SUBJECT: Transmittal of Revised Responses to AP1000 DSER Open Items

**AP1000 Design Certification Review
Draft Safety Evaluation Report Open Item Non-Proprietary Responses**

DSER Open Item Number: 19.1.10.1-5 (Response Revision 1)

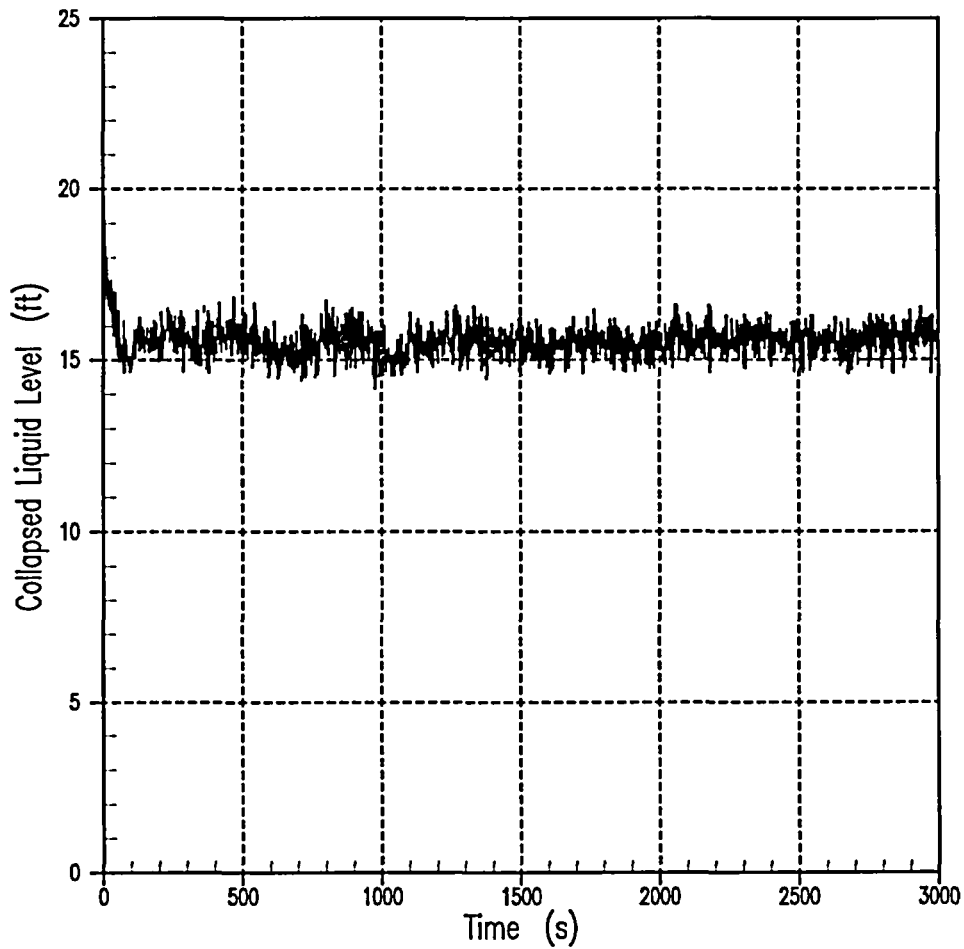
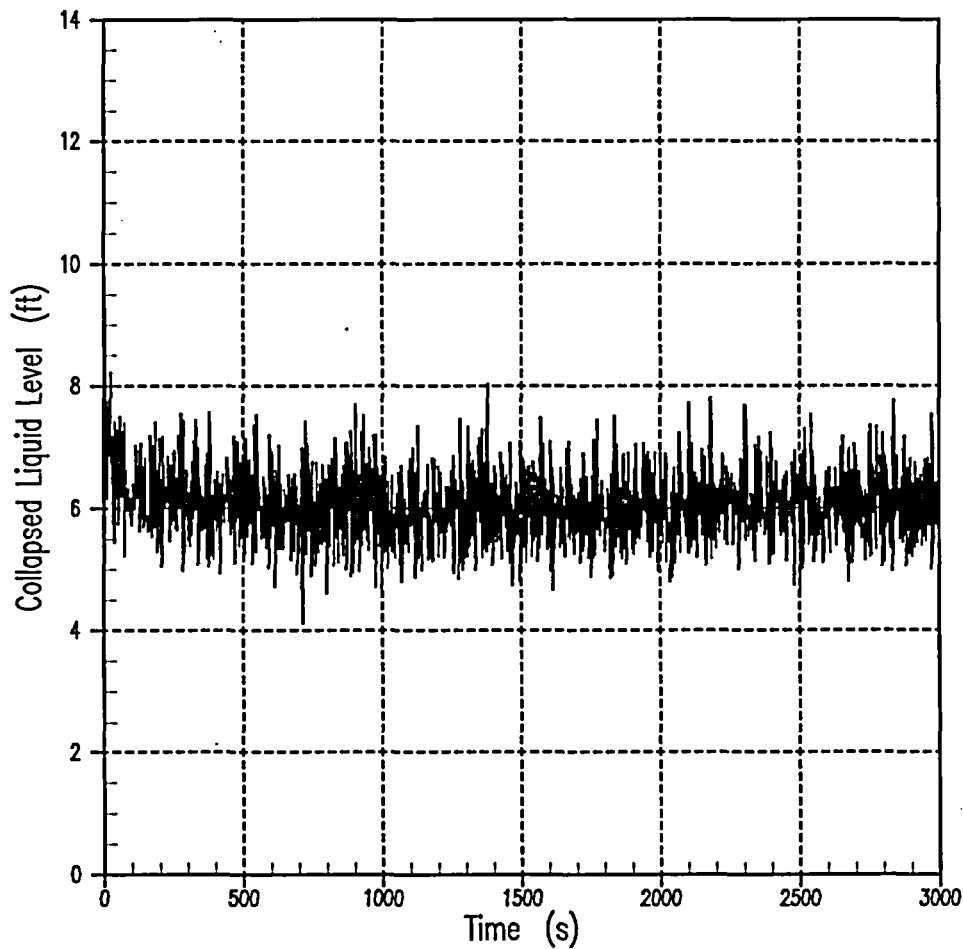
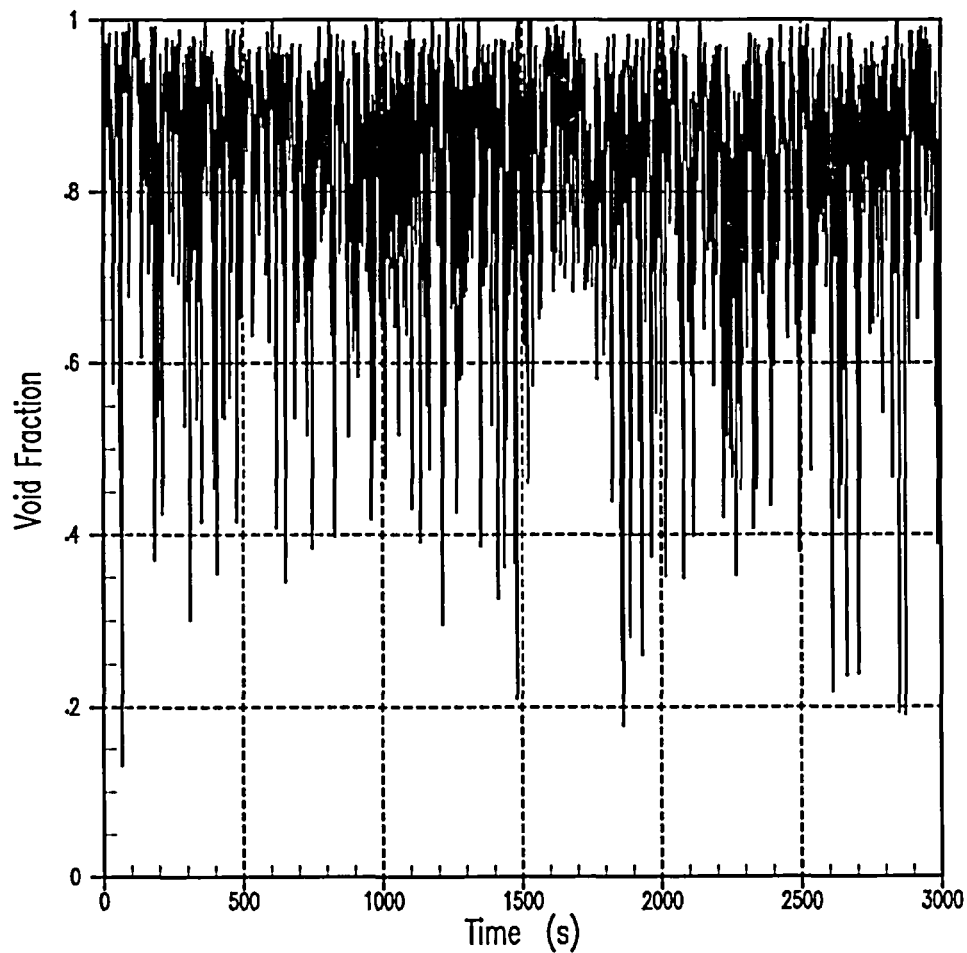
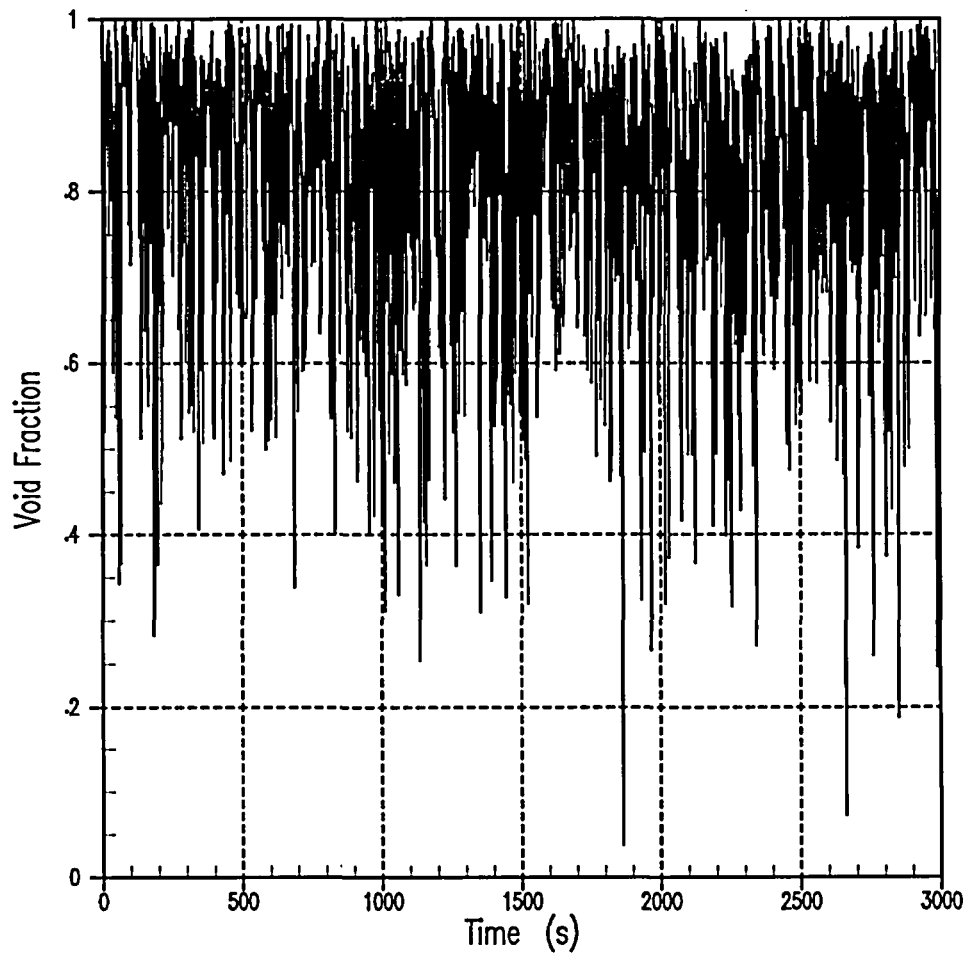
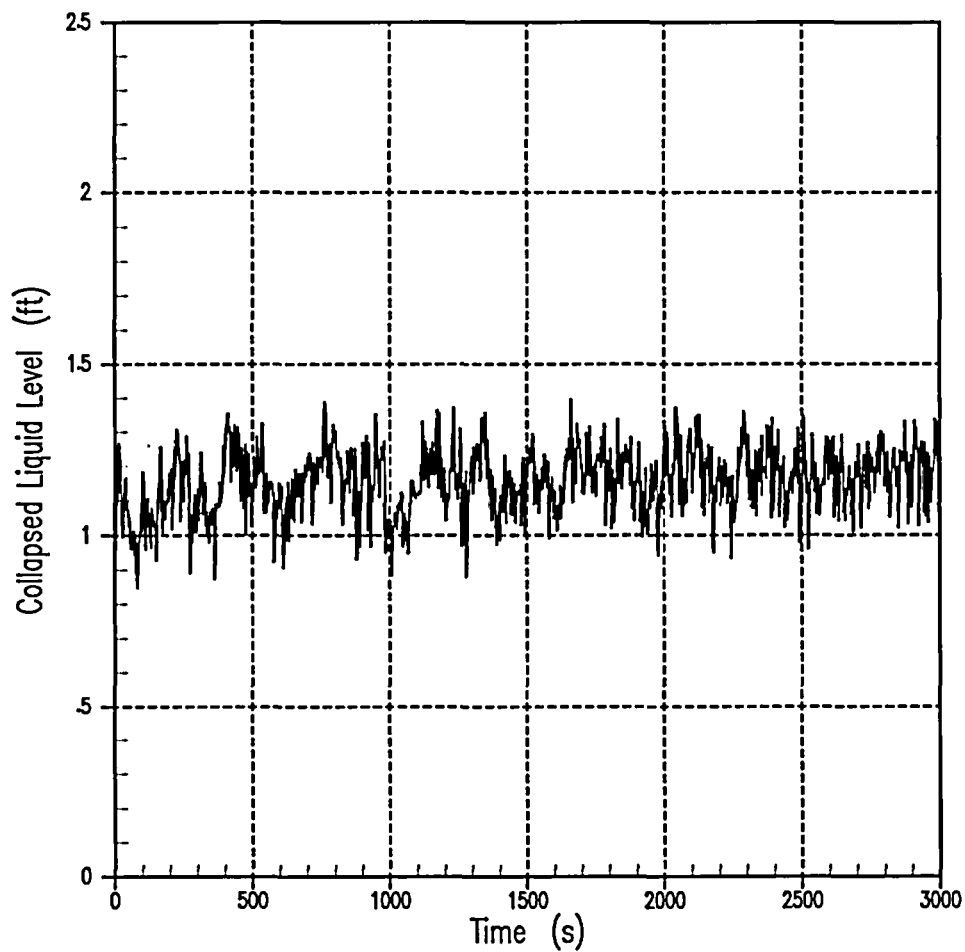
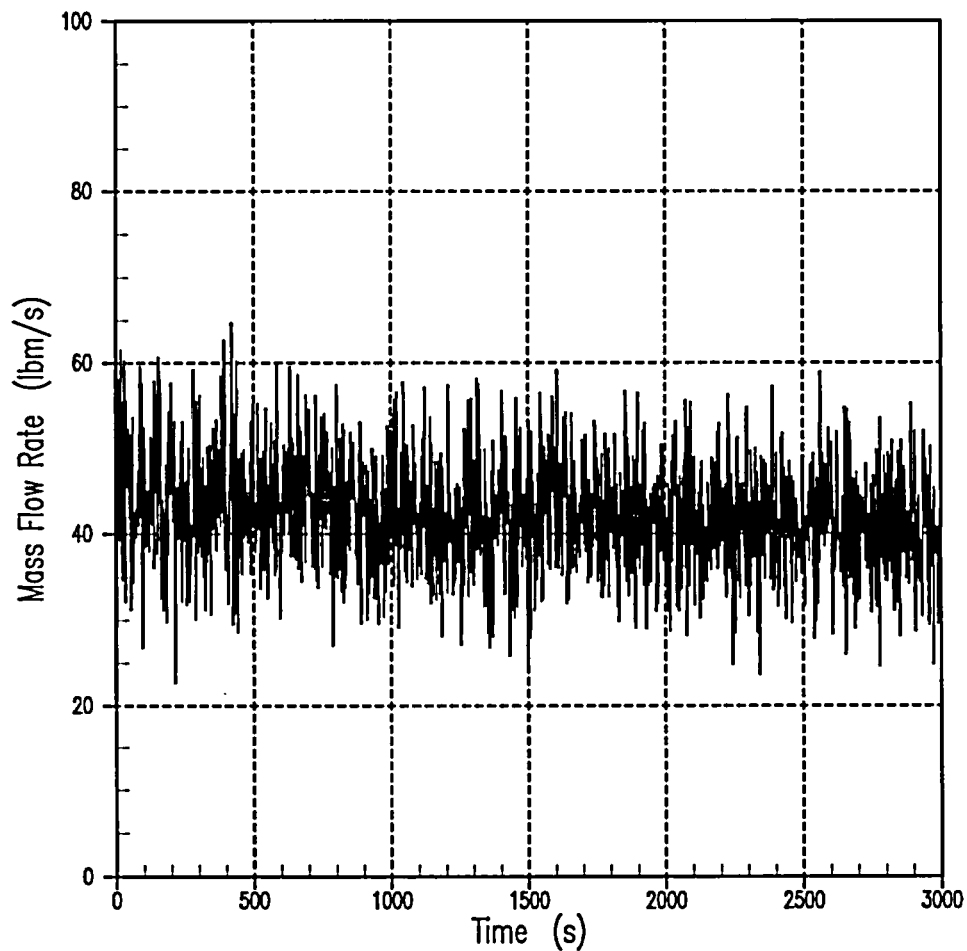
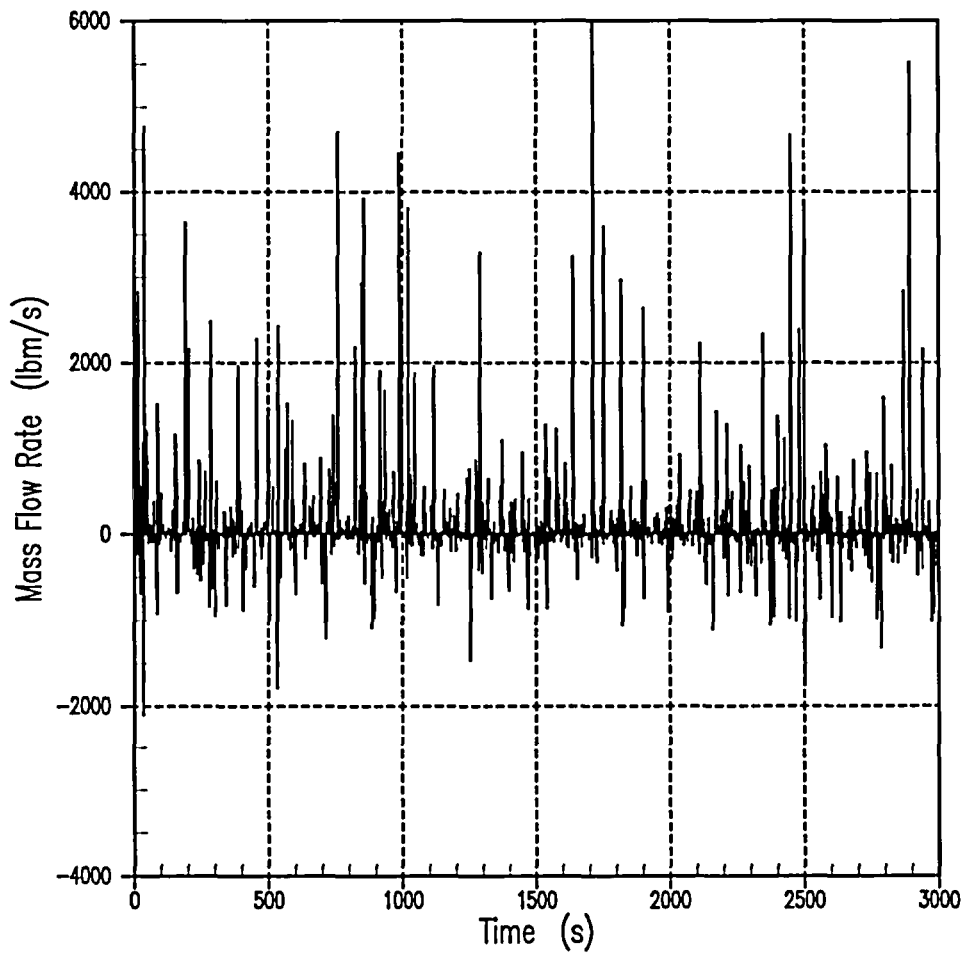
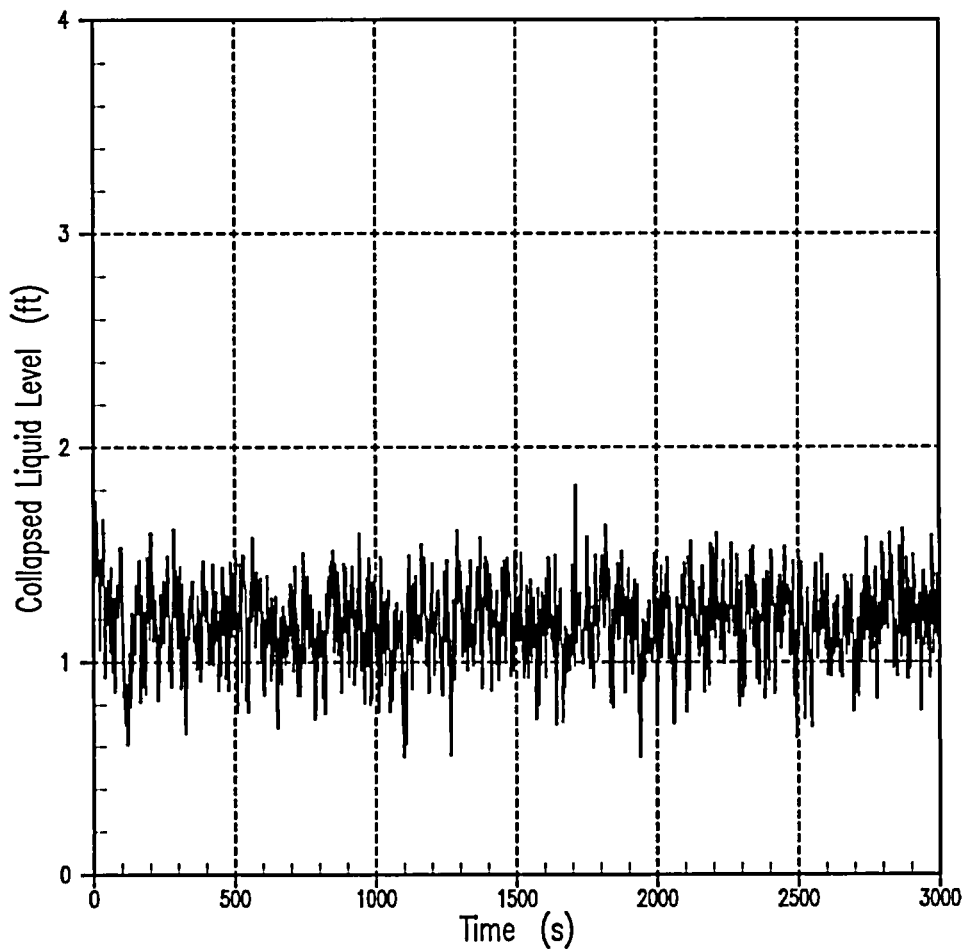
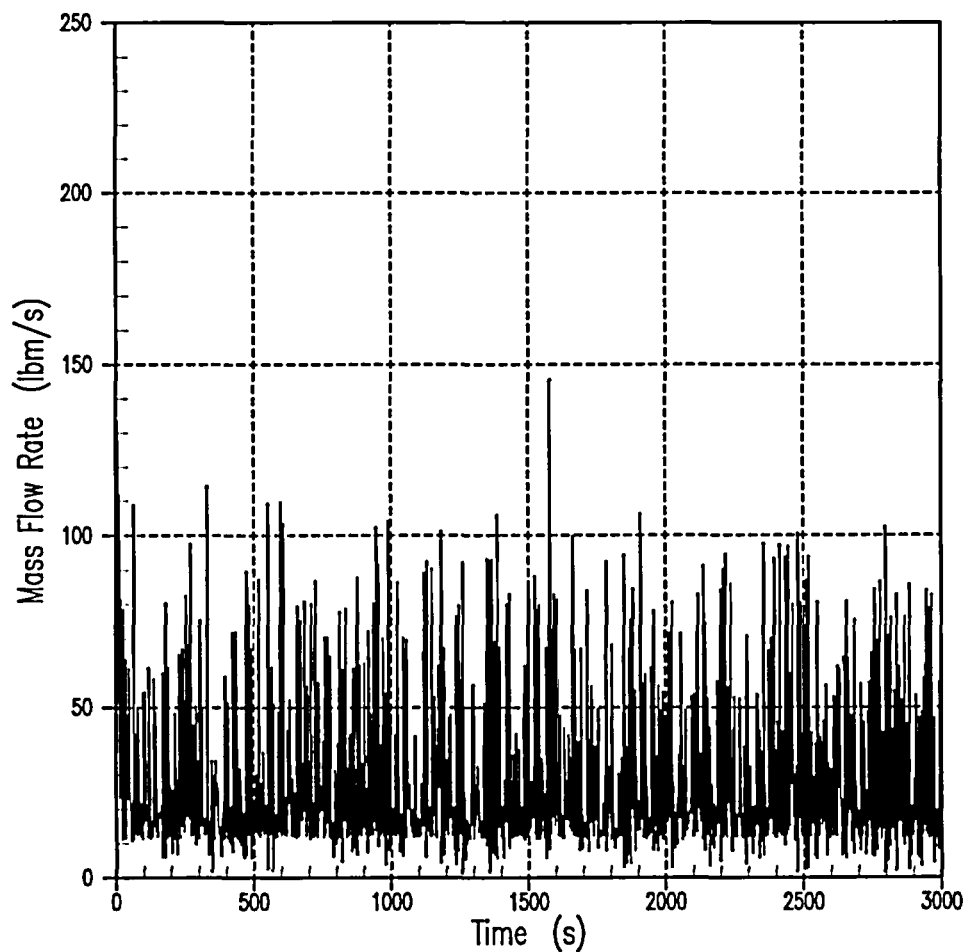
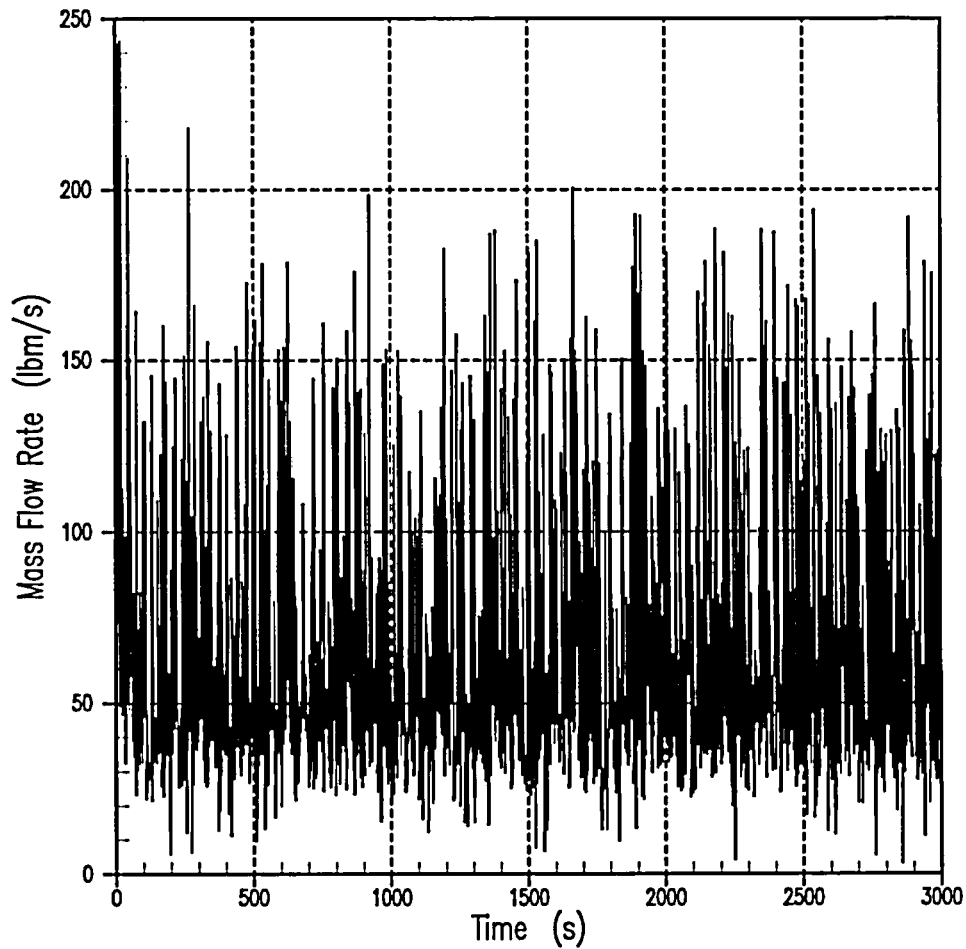
This issue remains open. In the revised response to RAI 720.013, Westinghouse performed long term cooling analyses for bounding conditions in the PRA. (Case F DEDVI, 1 CMT, 1 recirc line, 3/4 ADS4 and CI) and (Case G DEDVI, 1 CMT, 1 recirc line, 4/4 ADS4 and CI failure). The WCOBRA/TRAC code was used for LTC calculations with input conditions derived from MAAP4 analyses. As discussed in the DSER the staff has not reviewed MAAP4 except for its use in screening studies. These are analyses using minimum equipment sets as discussed in the DSER. The staff believes that only a methodology the staff has reviewed should be utilized. In addition, as a result of staff and ACRS questions, the WCOBRA/TRAC long term cooling model has been changed. The staff believes that the revised model should be used in these bounding calculations.

- (a) The long term cooling success criteria analysis case and the thermal hydraulic uncertainty cases F and G have now been performed using the revised WCOBRA/TRAC model and using input conditions from WGOETHIC. The revised cases replace the previous cases as shown below in the revision to PRA Appendix A.

Initially, the only injection comes from the IRWST into the reactor vessel through the intact DVI injection line (Figure A5.3-28). Since at the beginning of the analysis, the level in the PXS-B room is below the DVI injection nozzle elevation, only steam from the downcomer is vented out through the break. Water starts to flow back into the downcomer through the broken DVI line about 2 hours into the transient. This is the time when the level has about reached its minimum value in containment, yet decay heat is still relatively high in the PXS-B room becomes high enough to provide sufficient driving head for this to happen. This time, unlike the Case F DVI break scenario, the transition into reversed injection of water through the break into the downcomer occurs a little earlier, and is somewhat softer. As a result, the increased depressurization rate observed in Case F does not occur. Still, the levels in the downcomer (Figure A5.3-15), the reactor core (Figure A5.3-16) and the upper plenum (Figure A5.3-22) are maintained high enough by the available DVI injection to provide acceptable core cooling.

The availability of all ADS Stage 4 valves provides enough venting capacity to assure adequate depressurization and successful performance of the passive safety systems (Figures A5.3-23 and A5.3-24). The fuel remains covered throughout the transient, and adequate core cooling is provided to remove the decay heat. The hot rod cladding temperature at the top of the core is about 20°F above saturation (Figure A5.3-26) and steadily decreasing.
